MANDATORY SERVICE BULLETIN

MSB D4-099/1

Replacement of the aluminum turbo charger clamp with a steel clamp.

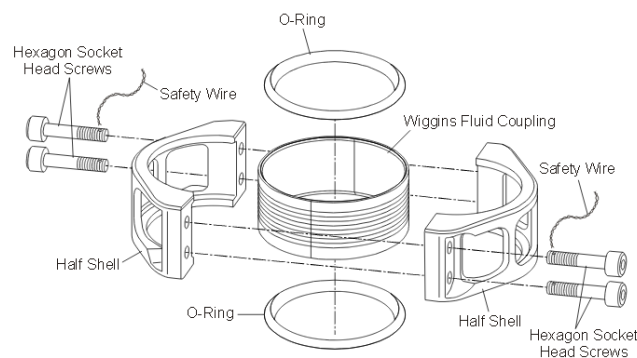
Note The K16 Turbocharger can be recognized by the form of the flange.

K16 turbocharger
Wide flange

turbocharger affected by this SB
Small flange
